Responses to Focused Initial Study Comments
4590 Patrick Henry Drive Residential Project

File Nos. PLN23-00290/PLN24-00310

October 2024

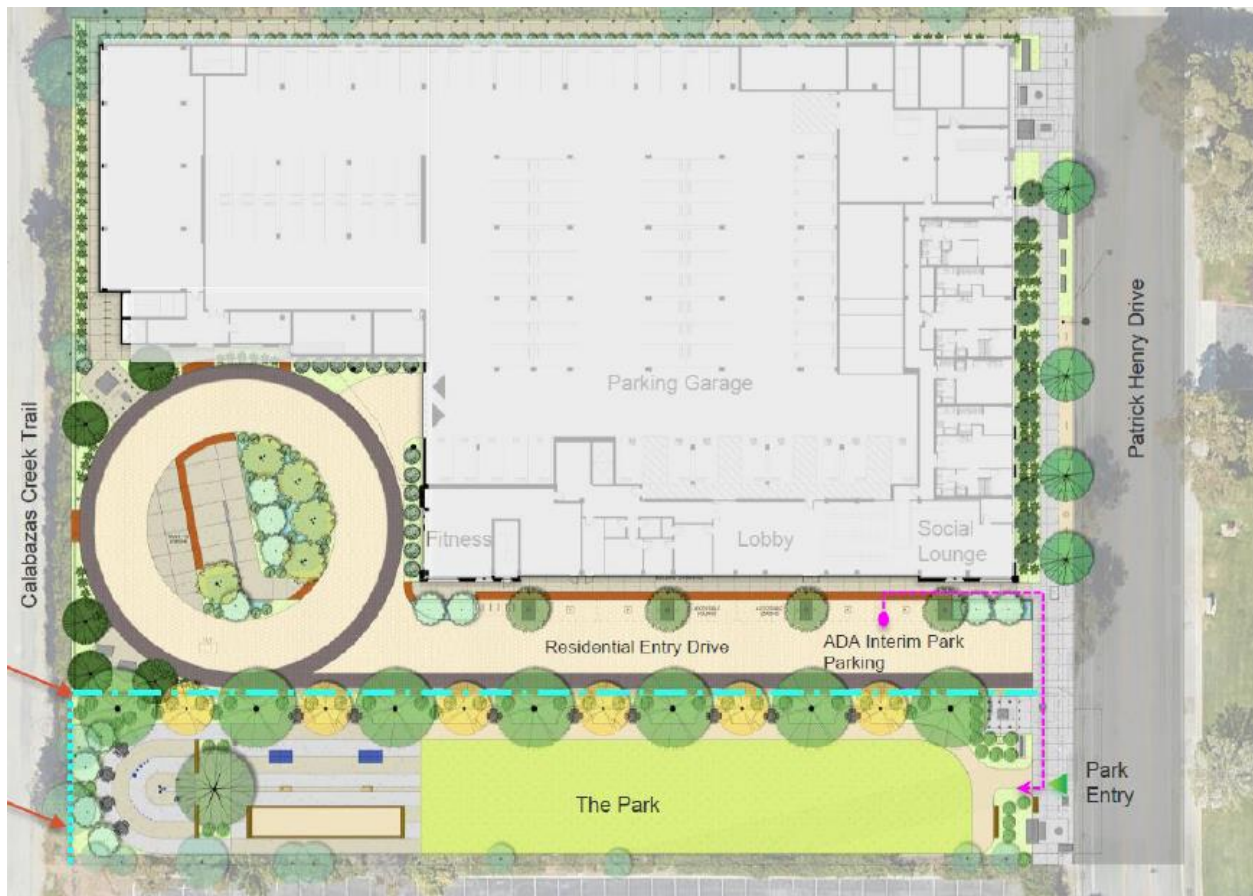
Comment D.4: The Applicant has also explored the onsite mitigation option, and discussed it with City staff. The mitigation measure indicates that the portion of the Project site on the western edge of the proposed public park would be sufficient for this purpose, but that in order to qualify, the currently planned "high-human use areas (such as exercise equipment and picnic tables)" would need to be moved to the east, out of the 0.14 acre area.⁷ For reference, the current design is as follows:

The Applicant has determined that redesigning the park as described in the mitigation measure is feasible from a practical perspective. The active areas could be shifted further east while maintaining all of the park's above-described features, and the western portion planted as required by the measure. The proposed park would not be open at night, so the no-lighting requirement is likewise not an issue. However, the Parks Department in particular has expressed that if the active elements are moved into the planned "lawn" portion of the park on the eastern side, the lawn would likely no longer qualify as such and the Project may therefore lose its fee credit for dedicating the park to the public, either for the 0.14 acre area or for the entire park. The impact of losing park fee credit is as follows:

Response D.4: The applicant's request for additional park fee credits under the City's Parkland Dedication Ordinance is not a CEQA comment. As of September 2024, the City of Santa Clara and the applicant have come to an agreement to accept the applicant's mitigation obligation in the public park because the applicant has been unable to secure mitigation off-site. As discussed in Mitigation Measure BIO(C)-1.1, on-site mitigation for the riparian encroachment can be achieved by revising the proposed public park design such that a 0.14-acre area (immediately adjacent to the western site boundary) incorporates native trees and shrubs, there is no night lighting, and high-human use areas are concentrated on the eastern portion of the proposed open space area (outside the 0.14-acre mitigation area). Refer to pages 130 to 132 of the Draft IS/MND for the full mitigation language. The applicant proposes to redesign the public park in compliance with Mitigation Measure BIO(C)-1.1. Redesign of the proposed public park would not require

Figure 3.0-4, Site Plan – Ground Floor will be **REVISED** as follows:

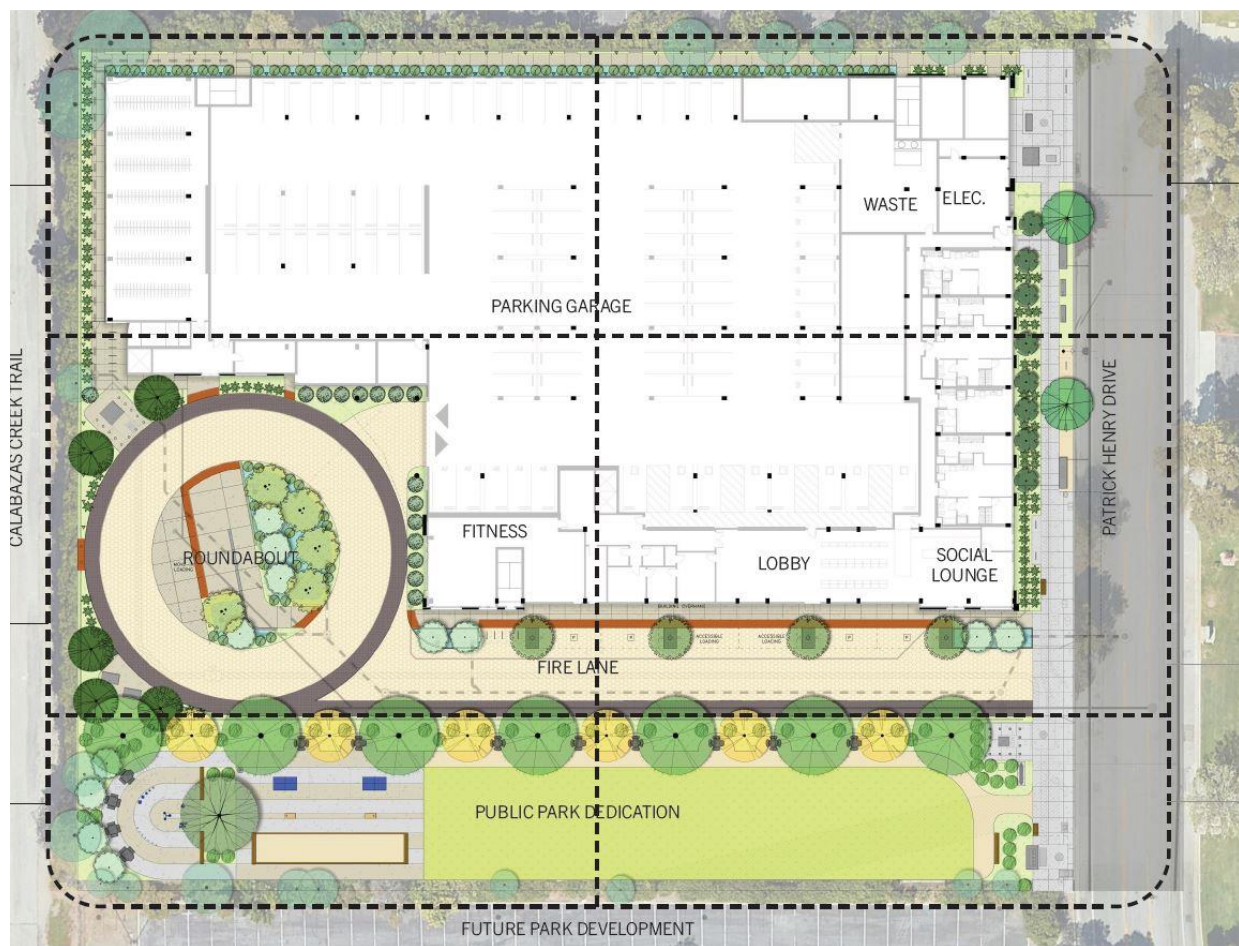
Figures 3.04 and 3.0-5: There are more current versions to replace these with, which the Applicant is enclosing if needed. Please check other figures as well.

Response D.8: The comment provides text corrections and current versions of the site plan and elevation to the Draft IS/MND. Refer to Section 3.0 Draft IS/MND Text Revisions. The requested text changes and updated graphics do not provide new information that would change the project's impact, provide new information that would require additional analysis or result in new significant impacts or mitigation measures than those analyzed and disclosed in the Draft IS/MND and associated appendices, or present new information that would require recirculation of the Draft IS/MND.

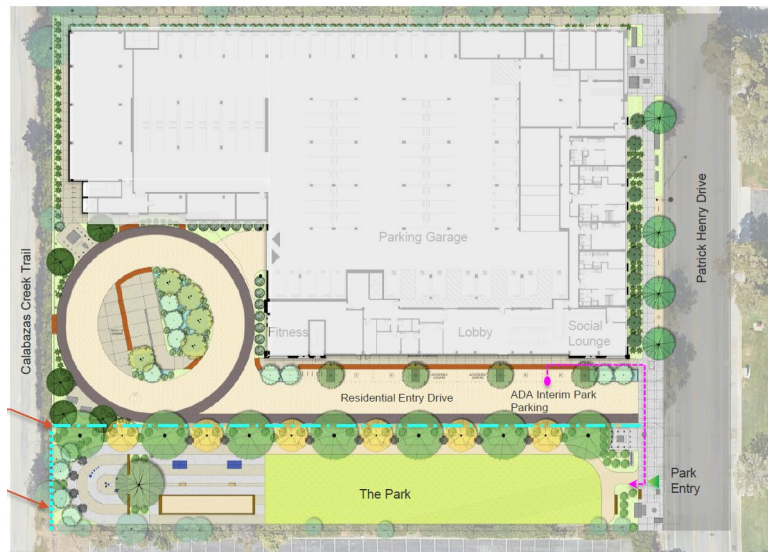
The Applicant has also explored the onsite mitigation option, and discussed it with City staff. The mitigation measure indicates that the portion of the Project site on the western edge of the proposed public park would be sufficient for this purpose, but that in order to qualify, the currently planned “high-human use areas (such as exercise equipment and picnic tables)” would need to be moved to the east, out of the 0.14 acre area.⁷ For reference, the current design is as follows:

The Applicant has determined that redesigning the park as described in the mitigation measure is feasible from a practical perspective. The active areas could be shifted further east while maintaining all of the park’s above-described features, and the western portion planted as required by the measure. The proposed park would not be open at night, so the no-lighting requirement is likewise not an issue. However, the Parks Department in particular has expressed that if the active elements are moved into the planned “lawn” portion of the park on the eastern side, the lawn would
